UNITED STATES PATENT AND TRADEMARK OFFICE

APPLICATION NO.	FILING DATE	FIRST NAMED INVENTOR	ATTORNEY DOCKET NO.	CONFIRMATION NO.
10/682,050	10/09/2003	Sidney E. Clark	03014/1086	8135
4743	7590	03/13/2006	EXAMINER	
MARSHALL, GERSTEIN & BORUN LLP 233 S. WACKER DRIVE, SUITE 6300 SEARS TOWER CHICAGO, IL 60606			BARRY, CHESTER T	
			ART UNIT	PAPER NUMBER
			1724

Office Action Summary

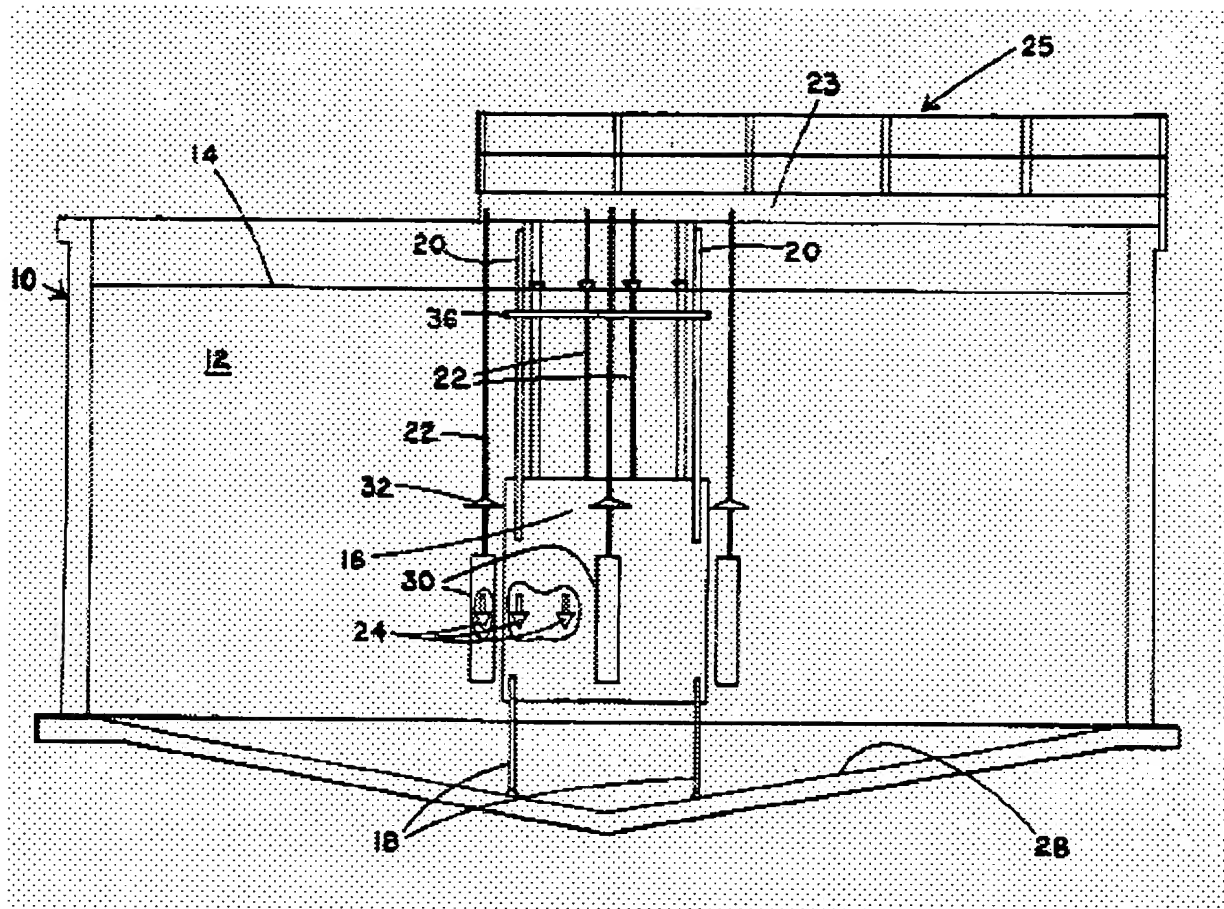
Claims 1 – 2, 4, 9, 10, 14 are rejected under 35 USC Sec. 102(b) as anticipated by USP 5779890 to Bailey.

Fig. 1 of Bailey shows an anaerobic digester with a sloping bottom, a shell, a top section, and a middle section. The digester has a main central draft tube 16 and six peripheral draft tubes 30. The flow motivater, i.e., "means for pumping liquid," is methane gas (4/11). The upper and lower ends of the draft tubes are within the interior space of the shell.

The draft tubes may be symmetrical about the central axis, as in Fig. 1 or Fig. 11, but need not be, as in Fig. 7. Per claim 10, each draft tube is near the centerline. Per claim 14, see Fig 1A and Fig 1B flow lines.

Fig 5 of US 20020192809 to Lanting describes a digester having two draft tubes 28, each of which has an inlet and outlet within the shell of the digester.

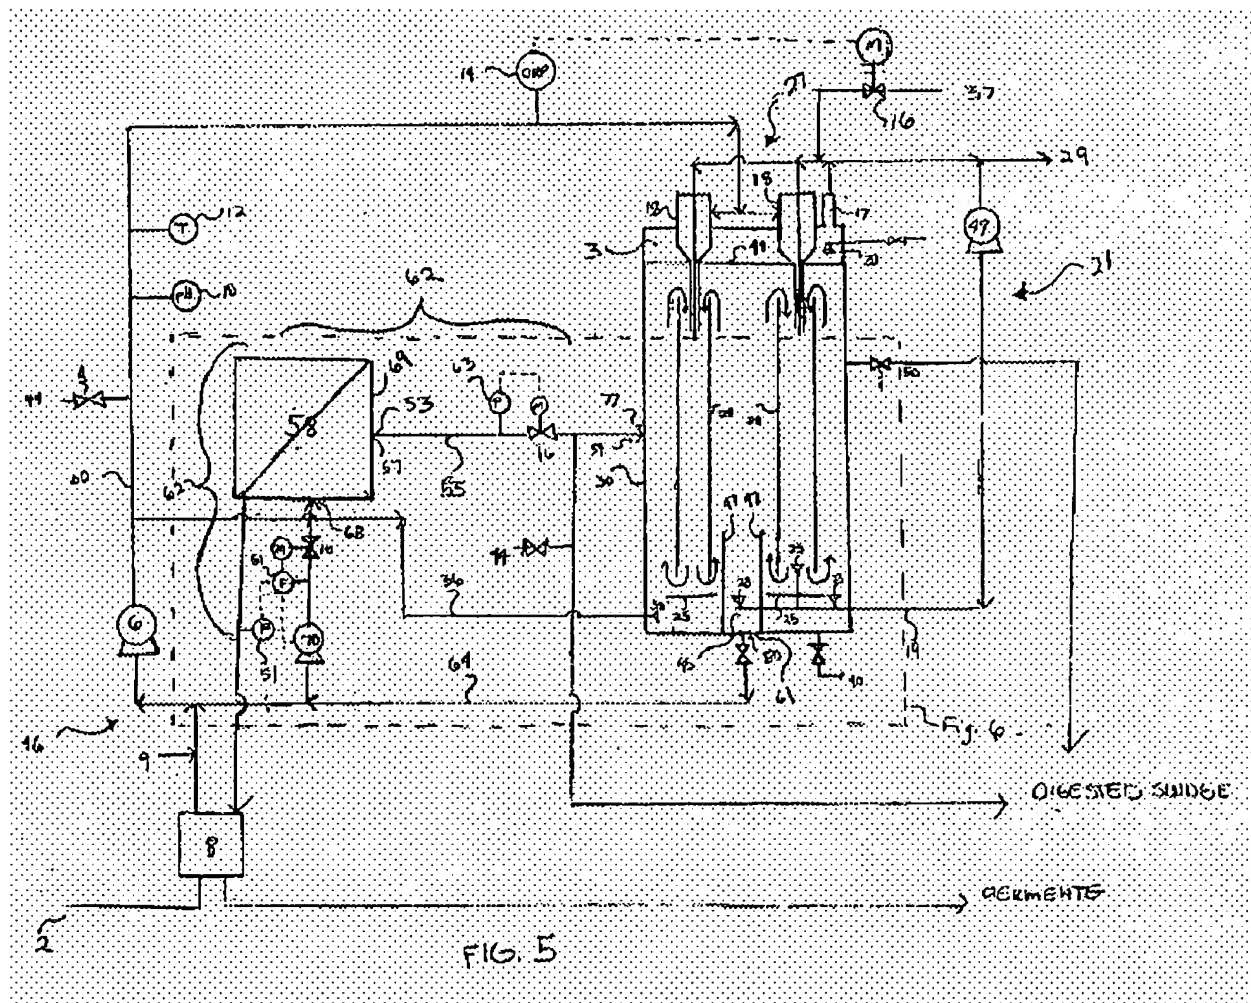
Note: At least one of the inlet and outlet of structures 18 and 47 is not "in" the shell.

Paragraph [0008] teaches away from modification of the flat-bottom digesters described in Lanting to one having a bottom with sloped sides.
